APPEAL SUMMARY

Appeal ID: 21887	Project Address: 3060 NW Wilson St
Hearing Date: 9/18/19	Appellant Name: Nicholas Locke
Case No.: B-003	Appellant Phone: 7752764250
Appeal Type: Building	Plans Examiner/Inspector: Sloan Shelton
Project Type: residential	Stories: 2 Occupancy: Single Family Construction Type: V-B
Building/Business Name: 3060 NW	Fire Sprinklers: No
Appeal Involves: Alteration of an existing structure	LUR or Permit Application No.: 19-222120-RS
Plan Submitted Option: pdf [File 1]	Proposed use: ADU

Appeal item 1

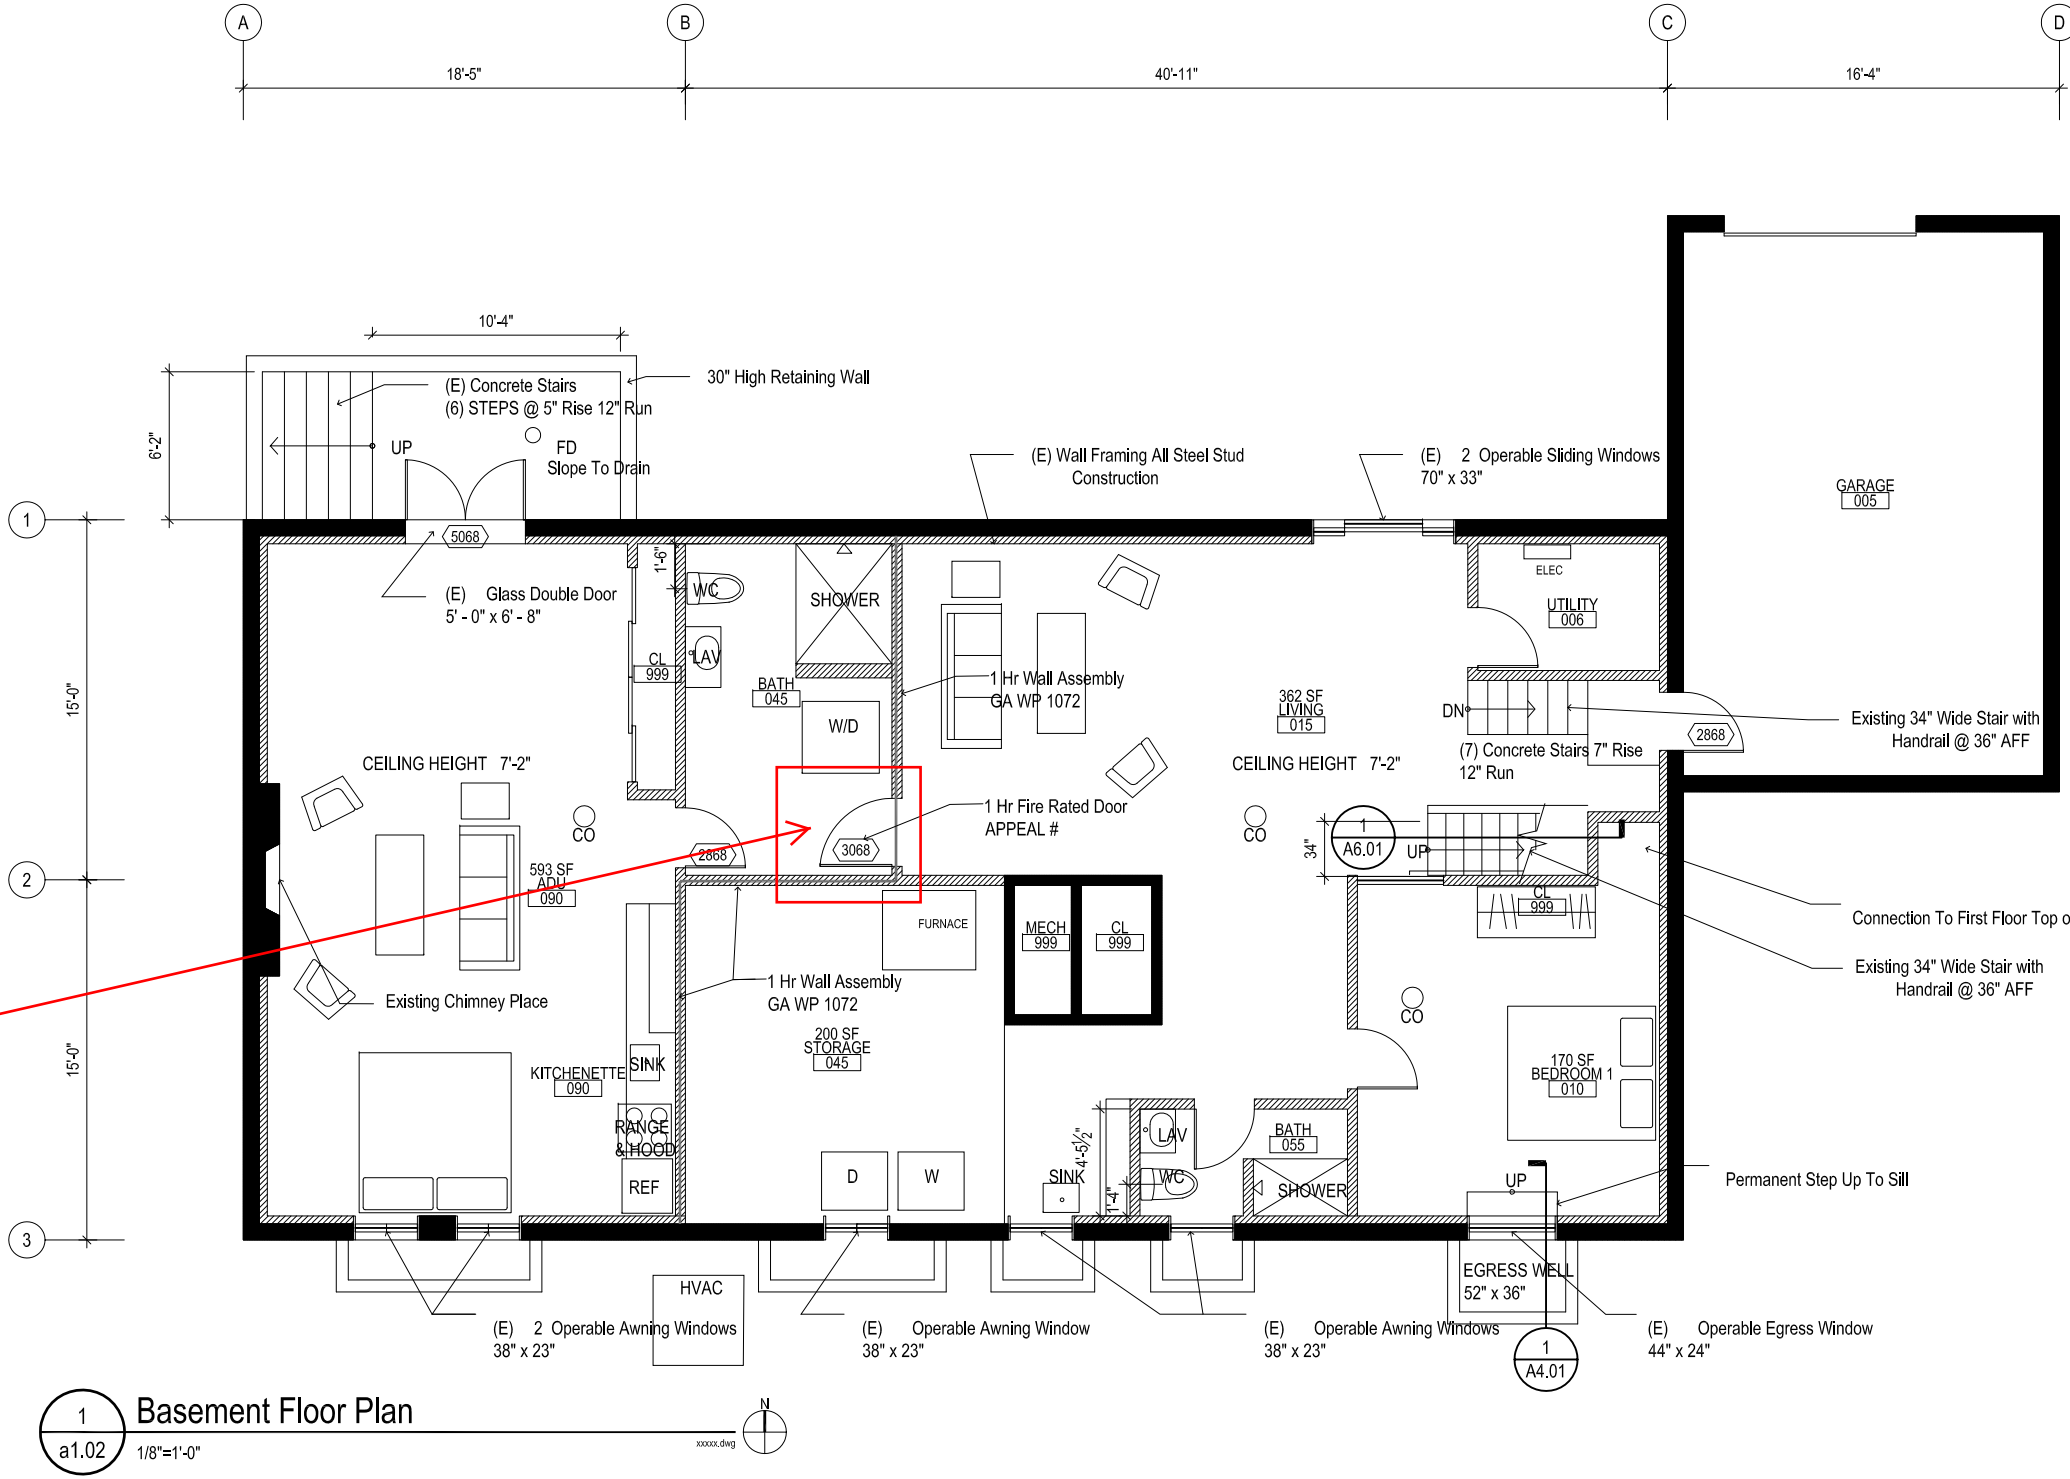
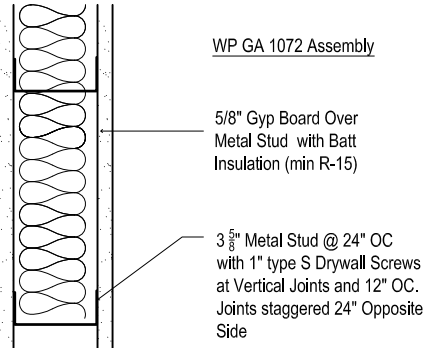
Proposed Design	<p>Consistent with the BDS document “Program Guide - Accessory Dwelling Units” at page 12, section V.D.2.a.1.,</p> <p>we propose to allow a 3 ' 0" W x 6'8" H solid 60-minute fire-rated door on the interior wall separating the ADU from the existing finished basement, as shown on the accompanying plan document. This Existing Door will have a closer and smoke gasket installed to further meet the program guide. The remaining wall sections between the ADU and the finished basement will be 1-hour rated, per the existing plans.</p>
Reason for alternative	<p>The proposal will satisfy existing building and fire codes, and will be consistent with the BDS document “Program Guide - Accessory Dwelling Units.”</p> <p>It will also facilitate the efficient use of our ADU space by allowing for dual uses, as was our original intent with the project:</p> <p>With the interior ADU door closed and locked, it will provide for safe, secure, and private living space for occasional renters or other short-term occupants.</p> <p>With the interior ADU door open and unlocked, it will provide space for our family and friends to use that allows for convenient access to the rest of the house.</p>

This Existing Door Provides Communication Between the Proposed ADU and the Main Dwelling Unit.

Communicating door between ADU and main dwelling unit: Granted provided the separation wall is full 1 hour fire rated construction without reductions allowed in ADU Program Guide.
Appellant may contact John Butler (503 823-7339) with questions.
